# Product Change Notification

PCN-4537-A2-HD25A

Date of Notification	Change	Part Numbers Affected
August 18, 2014	<input type="checkbox"/> Major <input checked="" type="checkbox"/> Minor	A2, A2K, A2T, HD25A

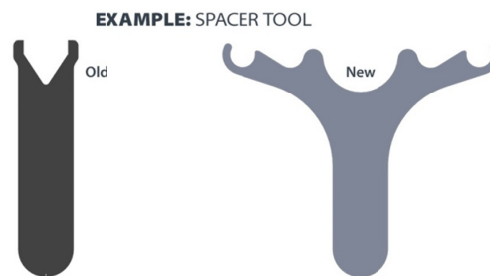
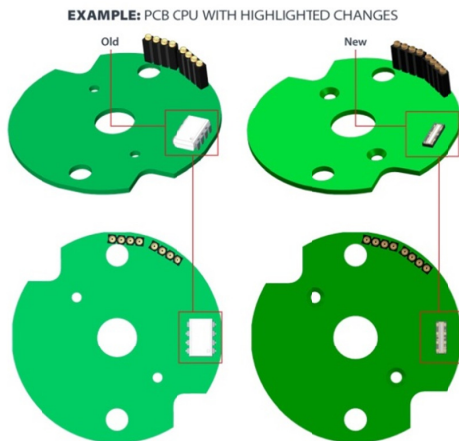
Description and Extent of Change: We have improved the design by utilizing surface mount devices for the detector and LED, previously these were through hole devices. This change is transparent with the exception of minor cosmetic differences for the A2 kit style encoder, and Spacer Tool used in kit assembly process. The changes are demonstrated in the images below.

Reason for the change: The current detector is at EOL as well as to improve robustness and reliability by utilizing SMT devices.

Effect of Change on Fit, Form, Function , Quality, or Reliability: The changes made have no effect on fit, form or function and both Products continue to meet all published performance parameters. Quality and reliability assessment have been completed with the product qualification meet US Digital’s reliability requirements. A comprehensive qualification report is available upon request.
